Access Compliance Report

Public Rights-of-Way

(Curb Ramps)

Intersection ID: 16072	Main Street: MONROE_RD	Cross Street: RICHLAND_DR	Location: NE
ADA ID: FC07ADE6579D	Ramp Type: Perp	Initial Pass/Fail: Fail	Overall Compliance: No
Severity Score: 8.75			
Codes/Mitigation Info/Possible Solution		Field Measurements/Component Compliance

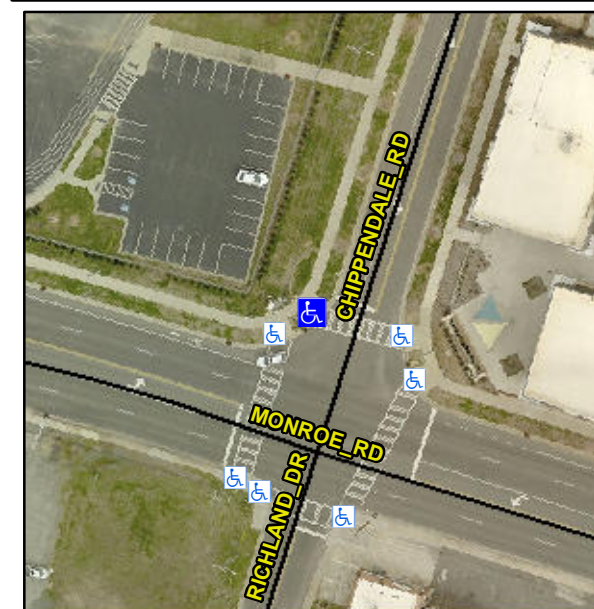
Not Found, R304.5.1

Compliance	Description	Data	Compliance	Description	Data
N/A	Ramp Length (in)	96.0	Yes	Ramp Slope (%)	5.1
No	Ramp Width (in)	46.0	Yes	Ramp XSlope (%)	1.3
N/A	Flare Type LT	N/A	N/A	Flare Type RT	N/A
N/A	Flare Slope LT (%)	N/A	N/A	Flare Slope RT (%)	N/A
N/A	Flare Traversable LT?	N/A	N/A	Flare Traversable RT?	N/A
N/A	Landing Length (in)	N/A	N/A	DWS Provided?	N/A
N/A	Landing Width (in)	N/A	N/A	DWS Contrast?	N/A
N/A	Landing Slope (%)	N/A	N/A	DWS Length (in)	N/A
N/A	Landing X Slope (%)	N/A	N/A	DWS Full Width?	N/A
N/A	Landing Curb? (Y/N)	N/A	N/A	DWS Offset (in)	N/A
N/A	Shared Landing?	N/A			
N/A	Gutter Ponding?	N/A	N/A	Gutter Slope (%)	N/A
N/A	Gutter Lip Ht (in)	N/A	N/A	Gutter X Slope (%)	N/A
N/A	Painted X Walk1?	Yes	N/A	Painted X Walk2?	N/A
	X Walk 1 Direction	To S		X Walk 2 Direction	N/A
N/A	X Walk 1 Width (in)	115.0	N/A	X Walk 2 Width (in)	N/A
	X Walk 1 Slope (%)	1.9		X Walk 2 Slope (%)	N/A
	X Walk 1 X Slope (%)	1.5		X Walk 2 X Slope (%)	N/A

Remove & Replace Entire Ramp.
